**DEPARTMENT OF TRANSPORTATION  
STATE OF GEORGIA**

**FILE:** EDS-84(26), HPPN-EDS-84(27) & NHN-007-03(28) **OFFICE:** Eng. Services  
Ware County  
P.I. Nos.: 522770, 522780 & 522775  
S.R. 38/U.S. 84 Widening/Reconstruction and Bridge Replacement

**SUBJECT: IMPLEMENTATION OF VALUE ENGINEERING STUDY ALTERNATIVES**

# VALUE ENGINEERING STUDY REPORT RESPONSES

VE Comment A-2  
Option 1

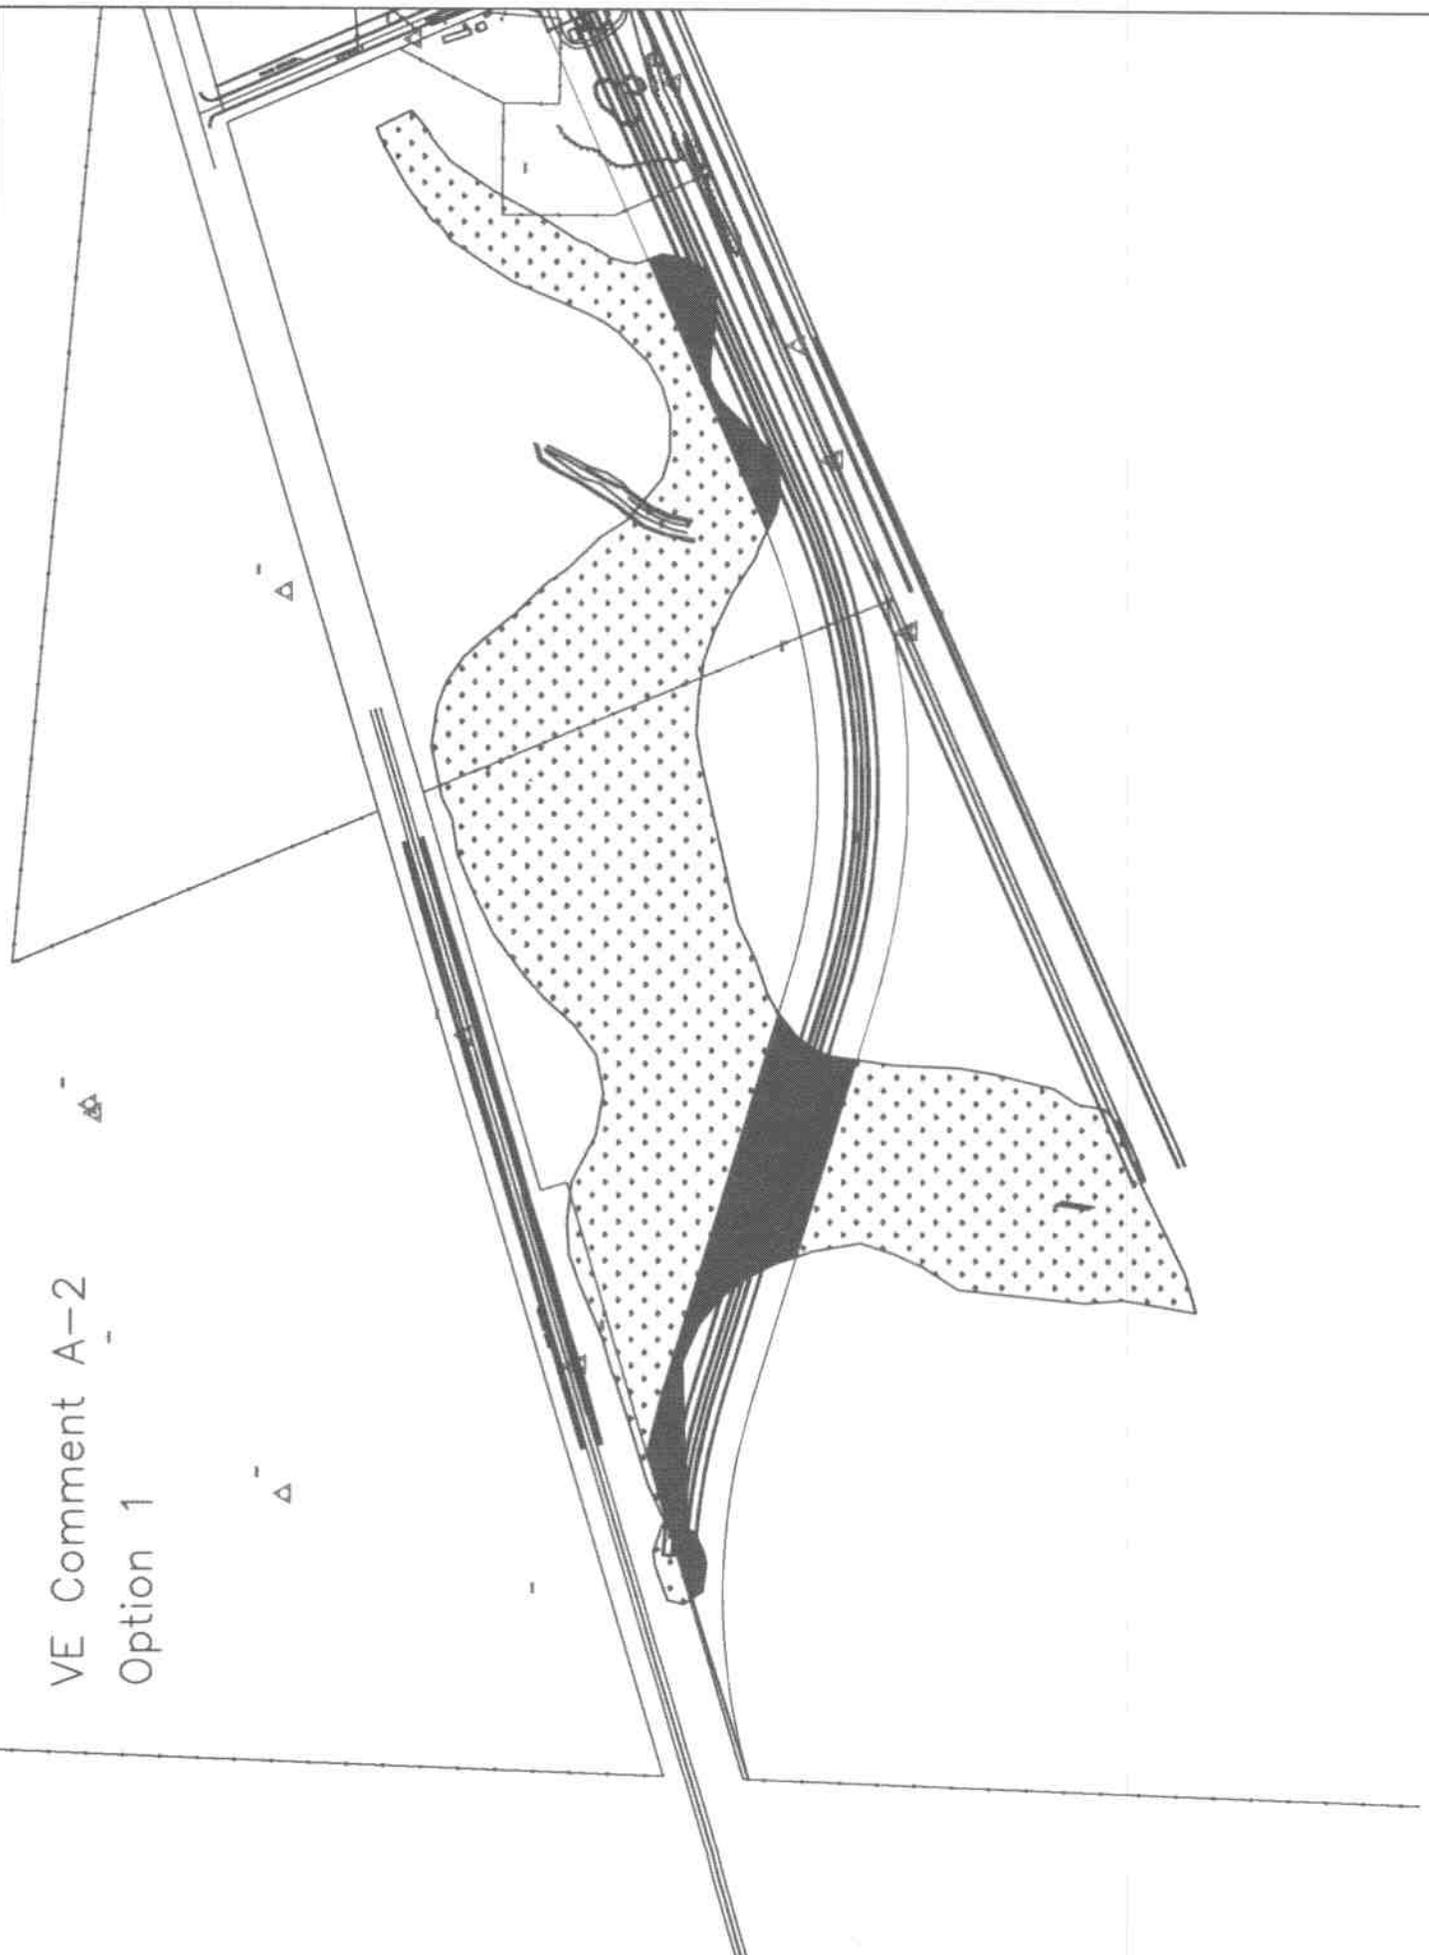
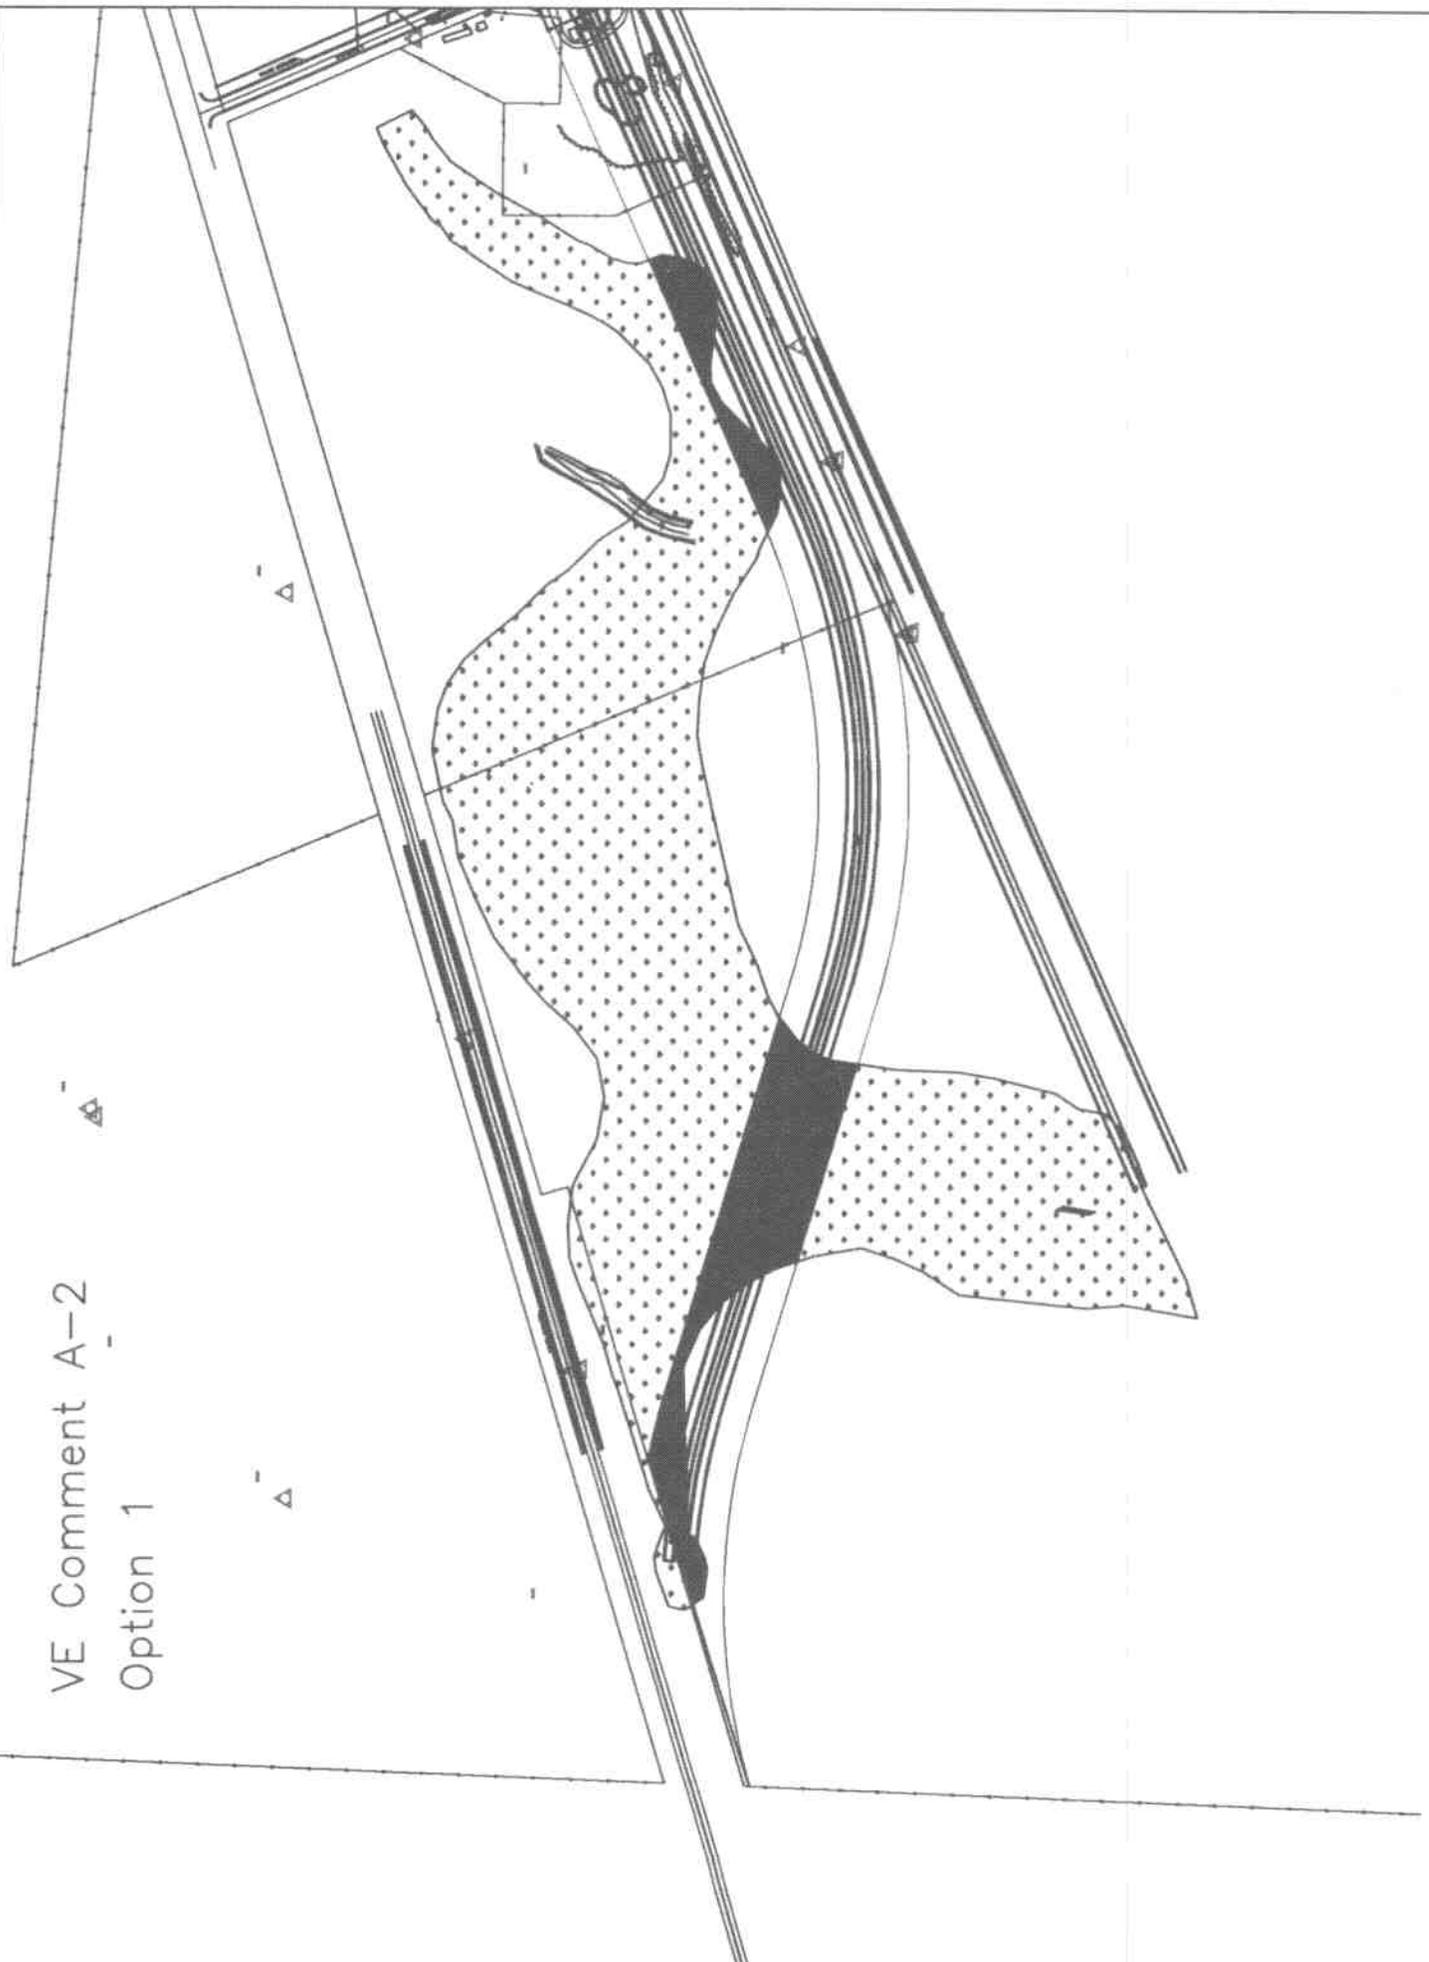
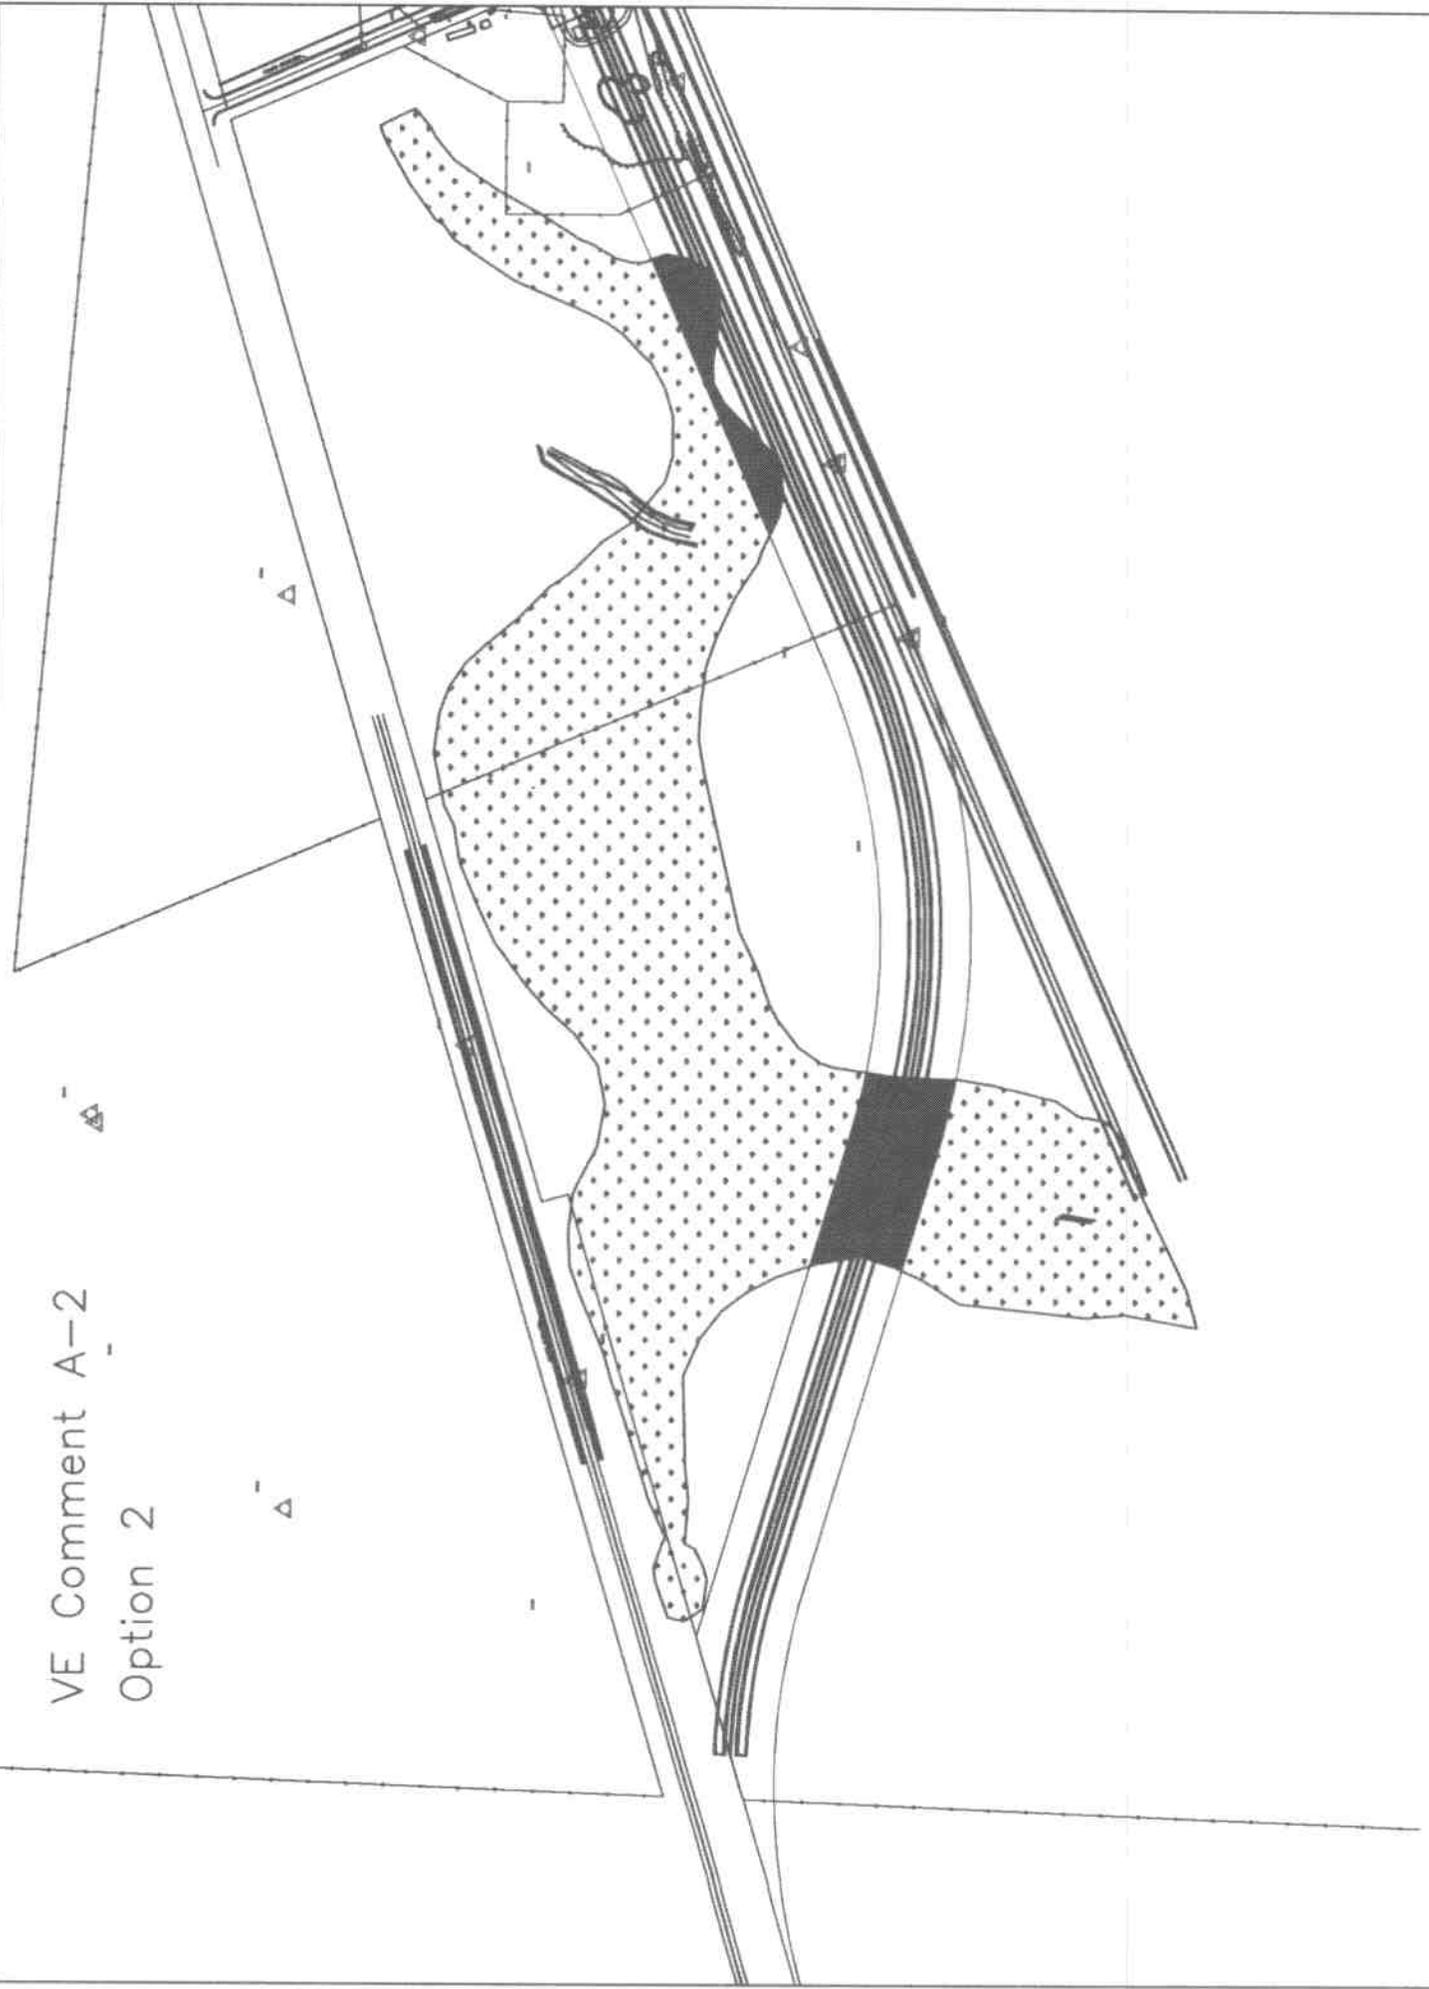
A-2 Reduce impacts to wetlands with new alignment at west end (increase wetlands identification) DS

The wetland areas shown on the plans are not inclusive of all areas other than those impacted by the original corridor. The actual area of wetlands in the surrounding vicinity is much larger. Therefore if the alignment were to be relocated as suggested by this comment, the impacts to wetlands would not be decreased as significantly as it would appear. For the first option the reduction would be 1.73 acres and for the second option the reduction would be 3.71 acres. Furthermore, the overall project costs will be increased due to the increase in required right-of-way as well as the increase in the new location paving quantities. The increase for the first option would be \$274,235 and for the second option the increase would be \$371,700. (See A-2 attachments)
